DEPARTMENT OF PLANNING  
STAFF REPORT

**PLANNING COMMISSION PUBLIC HEARING**

**DATE OF HEARING: October 15, 2007**  
**ZMAP 2006-0015, SPEX 2007-0007 – Arcola Center**  
**DECISION DEADLINE: February 2, 2008**  
**ELECTION DISTRICT: Dulles      PROJECT PLANNER: Ginny Rowen**

## Village Perimeter Transition Area

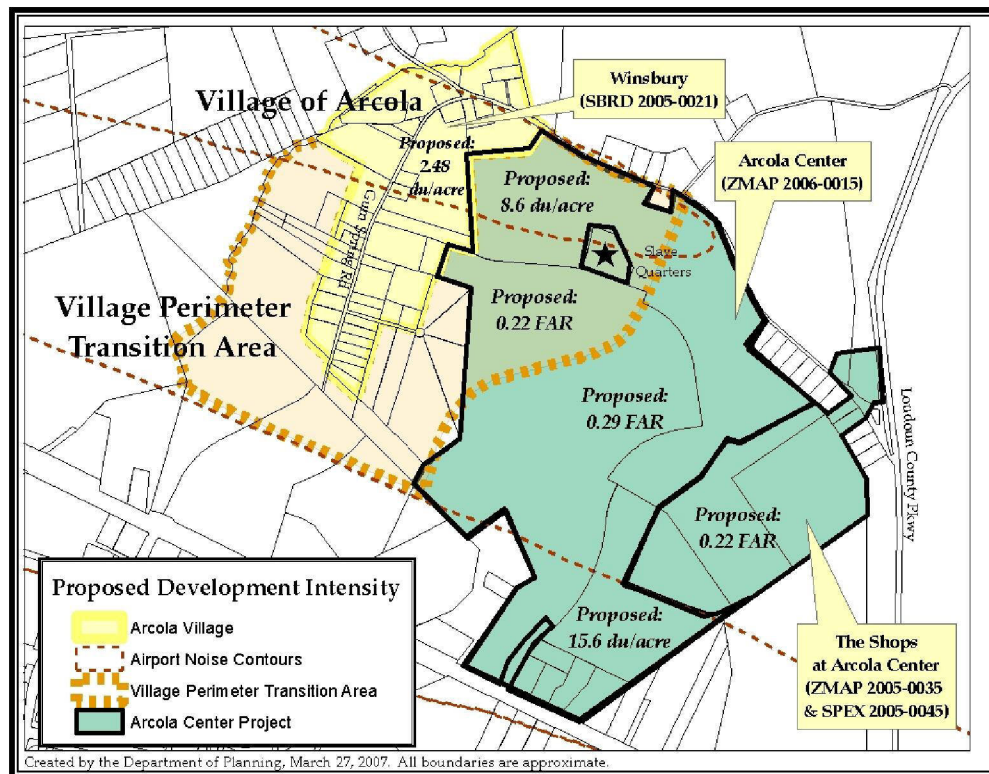
The proposed intensity of the development, in particular the residential density (8 units per acre), is not consistent with Plan policies. Rather than creating a transition between the higher intensity development to the east and the existing, low-density development pattern of the Village of Arcola, the residential densities and non-residential uses proposed in the Village Perimeter Transition Area are similar to those proposed in the remaining portion of the Arcola Center project and may be incompatible with the abutting Village of Arcola (see graphic below). For these reasons, staff recommends that the proposed development within the Village component be reduced so that a transition to the Village of Arcola is created.

At 8 dwelling units per acre, the proposal exceeds the upper density limit of 4 units per acre that the Plan envisions in the Village Perimeter Transition Area. Residential density calculations should be based on the residential land area rather than the entire area of the town center. The applicant is double-counting the area proposed for residential development with the area proposed for commercial development. In accordance with Plan policies, this application proposes commercial development within the Village Perimeter Transition Area that is located within the Ldn 65 noise contour (prohibits residential development). Only the residential land area should be used to calculate residential density.

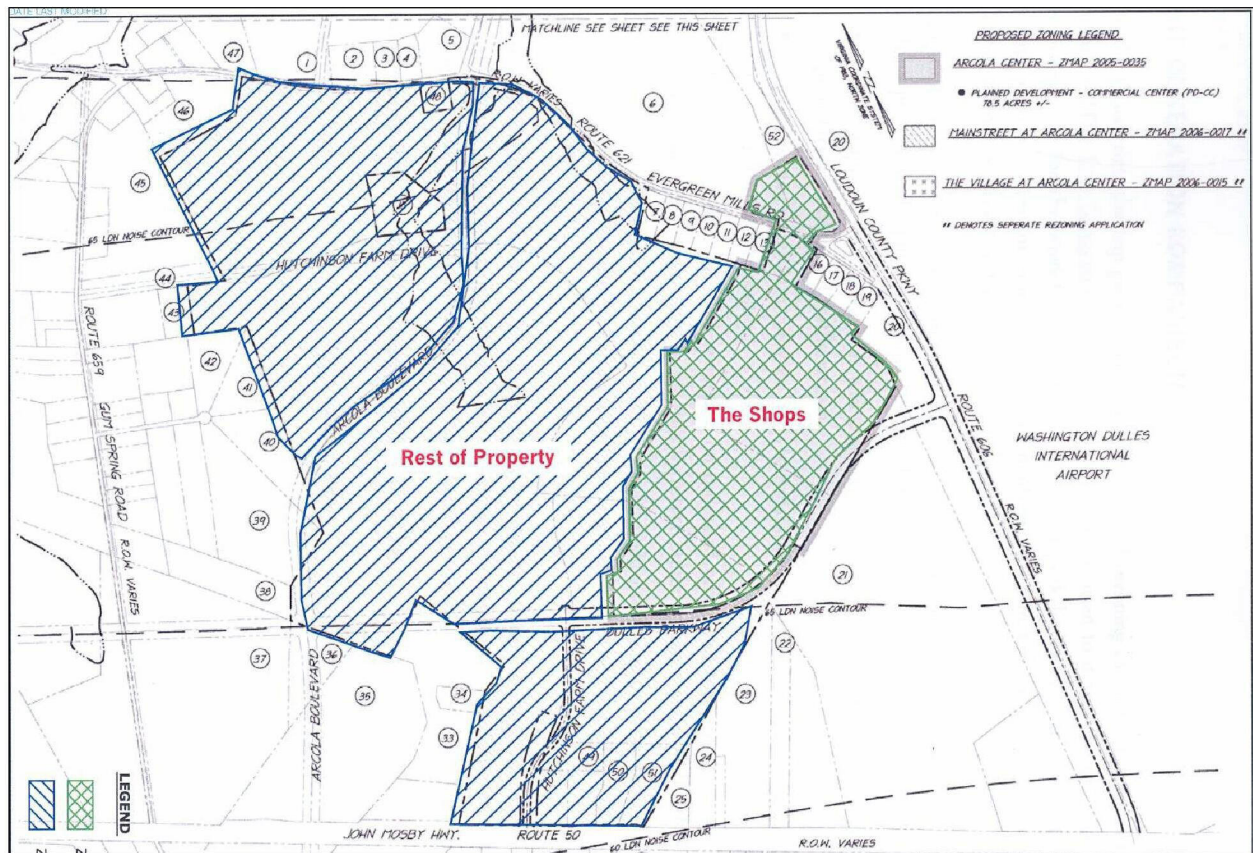
The special exception plat for the office uses is provided on sheet 17 of the concept plan. The Corporate Park, The Offices, and a portion of the Central Park components are located within the PD-IP portion of the site. The Main Street component comprises the PD-CC-RC portion of the site. Access to these components will be accommodated by Arcola Boulevard and Dulles South Parkway.

A special exception is required to develop more than 49% of the land area in a PD-IP (Industrial Park) zoning district as office use. The applicant is requesting the flexibility to develop up to 93% of the PD-IP portion of the site as office uses; however, the development of light industrial uses would still be permitted in the district. The concept plan depicts the PD-IP portion of the property as land bay 3, which is proposed along the eastern side of Arcola Boulevard.

1. The subject properties shall be developed in substantial conformance with the special exception plat (sheet 17) dated May 10, 2006, revised through August 6, 2007 prepared by Bowman Consulting. Approval of this application does not relieve the applicant of Zoning Ordinance, Codified Ordinance, or any other Ordinance requirements.
2. Exterior lighting shall be “full cut-off outdoor lighting fixtures” as defined by the Illuminating Engineering Society of North America (IESNA). Light shall be directed inward and downward toward the interior of the property, away from surrounding roads. Low-pressure sodium lamps shall be prohibited.
3. For all lighting placed on the exterior of the building, including security lighting, the maximum average illumination over the exterior of the building shall not exceed five (5) foot
